UNITED STATES PATENT AND TRADEMARK OFFICE

APPLICATION NO.	FILING DATE	FIRST NAMED INVENTOR	ATTORNEY DOCKET NO.	CONFIRMATION NO.
10/685,009	10/14/2003	Michael D. Gerdes	HE 8698US	4282

Office Action Summary	Application No. 10/685,009	Applicant(s) GERDES ET AL.	
	Examiner Travis M. Reis	Art Unit 2859

Attachment A

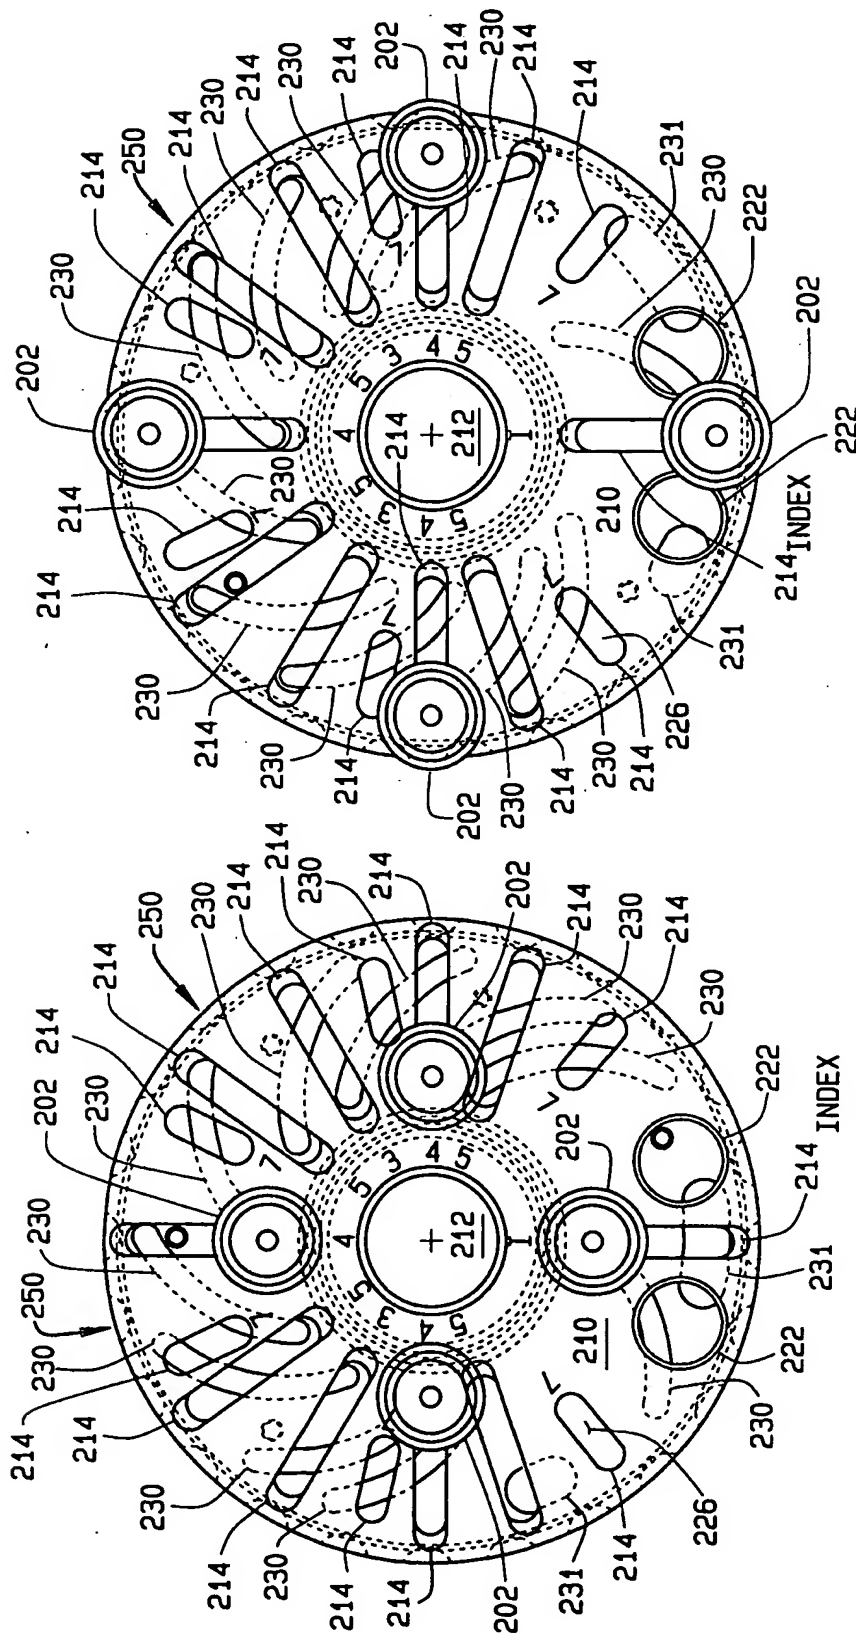
5. In response to applicant's arguments that the replacement of individual mounting flange plates disclosed by Mitchell with a singular plate disclosed by Warkotsch would result in a non-functional system and the illustration of combined mounting plates show that said plates cannot be combined; these arguments have been fully considered but they are not persuasive since as

shown in attachment A, the combination of the 3-slot configuration and the 4-slot configuration shows negligible intersection of slots and thus is a fully functional multiple-configuration plate.
